Department of Environmental Quality

**Re: DEQ Comments on the Gasco OU – Feasibility Study Report  
Former Gasco Manufactured Gas Plant Operable Unit  
Portland, Oregon  
ECSI# 84 and # 183**

The Oregon Department of Environmental Quality (DEQ) reviewed the *Feasibility Study Report*<sup>1</sup> (draft Gasco OU FS) for the Former Gasco Manufactured Gas Plant Operable Unit (Gasco OU) submitted by Anchor QEA, Ede Environmental, and Severson Environmental Services on behalf of NW Natural. The draft Gasco OU FS was prepared under the Voluntary Agreement for Remedial Investigation/Feasibility Study, as amended<sup>2,3,4</sup> (Upland Cleanup Agreement).

**Figure 3-26**  
Water Budget for the 2016 February-March Wet Period Transient Simulation  
Gasco Groundwater Modeling Report  
NW Natural Gasco Site

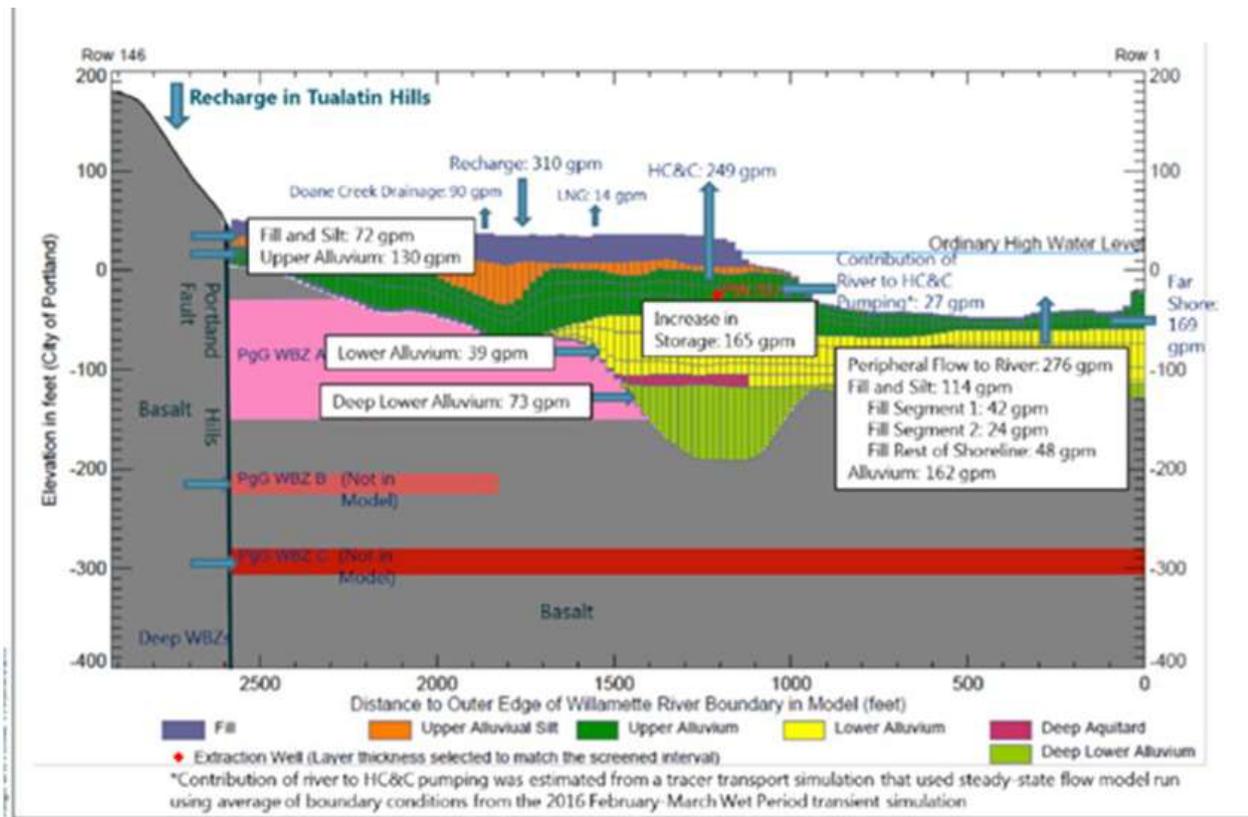
1. A table or cross section figure showing the water budget for the final calibrated model simulation. This table or cross section figure would include all elements of the inputs/outputs identified previously in the Gasco Groundwater Modeling Report calibration (**see example figure 3-26 below from an earlier NW Natural modeling report**).

EPA has asked for this groundwater model budget to be provided with their simulations (in cross section, or table format) for the past 3 years. EPA is still waiting for a response to this request.
